# Access Compliance Report

| Intersection ID: 12809                  | Main Street: N_MCDOWELL_ST | Cross Street: E_7TH_ST                  | Location: E            |
| ADA ID: C3B19F6E9755                    | Ramp Type: PerpDiag        | Initial Pass/Fail: Fail                 | Overall Compliance: No |

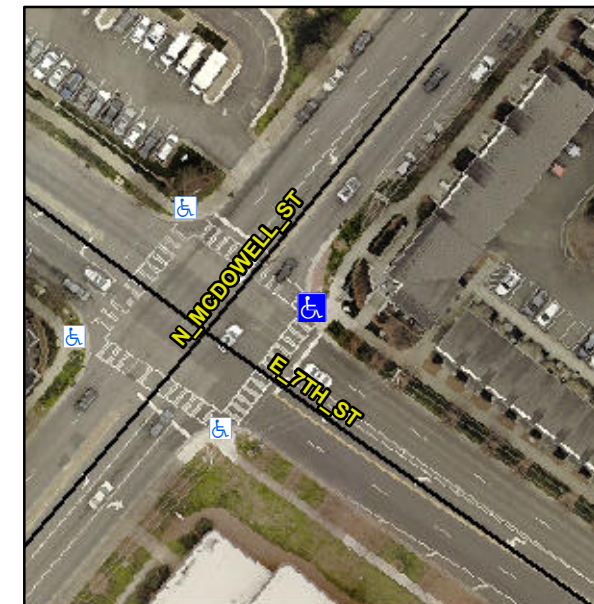
**Not Found, R304.2.2, R304.5.3**

| Compliance | Description           | Data  | Compliance | Description                 | Data  |
|------------|-----------------------|-------|------------|-----------------------------|-------|
| N/A        | Ramp Length (in)      | 103.0 | No         | Ramp Slope (%)              | 10.2  |
| Yes        | Ramp Width (in)       | 93.5  | No         | Ramp XSlope (%)             | 13.2  |

**Remove & Replace Curb Ramp With Two New Directional Ramps or Equivalent.**
